Green Line Implementation New Park at Macpherson Avenue and Davenport Road

What We Heard

Phase 2 - Preferred Concept Plan

April 2021

Figure 2. Macpherson Avenue Park Preferred Concept Plan

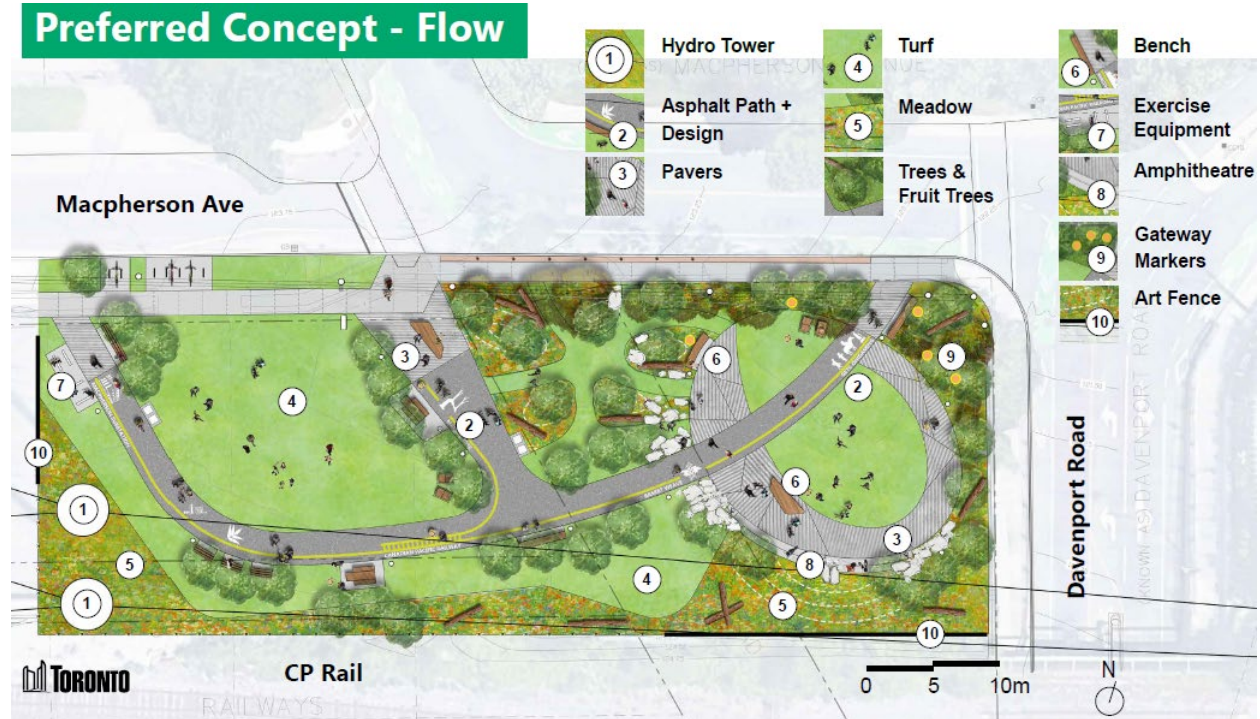
Overall, participants liked the Preferred Concept Plan and 89% indicated the design will meet the community's needs (Figure 3).

- The naturalized meadows, trees, and fruit trees;
- Site arrangement that meets needs and provides a sense of security;
- Park access is provided through the pathways.

- Consider extending the eastern art fence and changing the western art fence to represent something less well-known or visible in the current landscape of the neighbourhood that contributes to a broader historical, cultural, or social understanding of the area.
